UNITED STATES PATENT AND TRADEMARK OFFICE

Office Action Summary	Application No.	Applicant(s)	
	10/696,444	MICHELITSCH ET AL.	
	Examiner	Art Unit	
	SEOKYUN MOON	2629

DETAILED ACTION

Drawing 1

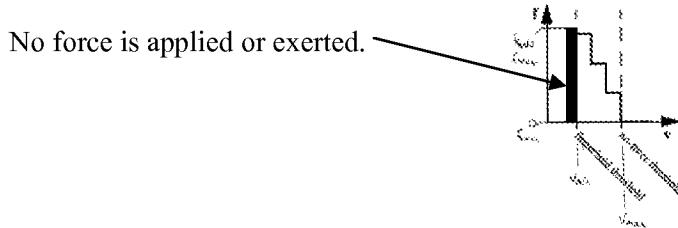
The Applicant [Remark: pg 8 4th paragraph] explained that the hold force, i.e. fhold or fmax, shown on figures 1a-1c is a value higher than any of the forces within the range between the interval Vmin and Vmax and thus the feature of claim 18, "*the predetermined hold force value being larger than the interaction feedback force within said inverted damping operation mode*" is well presented in the figures of the instant Application. The Examiner agrees with the Applicant's assertion that figures 1a-1c of the instant Application teaches the above disclosed claim limitation.

The Applicant [Remark: pg 8 5th paragraph] further explained, "*to be consistent with the specification and Applicant's Figures, fhold and fmax are marked on the ordinate of Figs. 1a-1c, and are not drawn as a bold line between 0 to Vmin of the abscissa, because fhold and fmax are substantially constant values that do not depend on different velocities in the range from 0 to Vmin*". However, the Examiner respectfully submits that the drawing objection made in the previous Office action was not based on the issue of drawing the applied force as a bold line or not, but was based on the issue of having a discontinuous region of the applied force in the graph. Specifically, claim 18 presented previously discloses, "an absolute value of the interaction force or a vectorial component thereof is increased in a position dependent form to a predetermined hold force value or above, if the respective velocity or a vectorial component thereof decreases below a given threshold minimum velocity value". However, figures 1a-1c of the instant Application show that no force exists in a certain range (the black region shown on drawing 1, which is equivalent to figure 1a of the instant Application) between 0 and Vmin. Thus, contrary to the feature disclosed in claims 18 and 35, the figures of the instant Application show

that, the absolute value of the interaction force is not increased to a predetermined hold force value or above even when the respective velocity decreases below a given threshold minimum velocity value. In other words, even though the black region is the region where the respective velocity decreases below a given threshold minimum velocity value, the absolute value of the interaction force is not increased to a predetermined hold force value or above.

Accordingly, the Examiner respectfully submits that the objection to the drawings is maintained in this Office action.

3. The drawings are objected to under 37 CFR 1.83(a). The drawings must show every feature of the invention specified in the claims. Therefore, the limitation, "*an absolute force value of the interaction feedback force or a vectorial component thereof is increased in a position dependent form, to a predetermined hold force value or above, if the respective velocity or a vectorial component thereof*

decreases below a given threshold minimum velocity value”, disclosed in claims 18 and 35 must be shown or the feature(s) canceled from the claim(s). Specifically, in figure 1, Vmin is defined as the threshold minimum velocity value. However, within a certain sub-range of the range of the velocity between 0 and Vmin, the interaction feedback force does not exist. In other words, within the sub-range, the interaction feedback force is not increased to a predetermined hold force value, even though the respective velocity is below the threshold minimum velocity value.

Corrected drawing sheets in compliance with 37 CFR 1.121(d) are required in reply to the Office action to avoid abandonment of the application. Any amended replacement drawing sheet should include all of the figures appearing on the immediate prior version of the sheet, even if only one figure is being amended. The figure or figure number of an amended drawing should not be labeled as “amended.” If a drawing figure is to be canceled, the appropriate figure must be removed from the replacement sheet, and where necessary, the remaining figures must be renumbered and appropriate changes made to the brief description of the several views of the drawings for consistency. Additional replacement sheets may be necessary to show the renumbering of the remaining figures. Each drawing sheet submitted after the filing date of an application must be labeled in the top margin as either “Replacement Sheet” or “New Sheet” pursuant to 37 CFR 1.121(d). If the changes are not accepted by the examiner, the applicant will be notified and informed of any required corrective action in the next Office action. The objection to the drawings will not be held in abeyance.
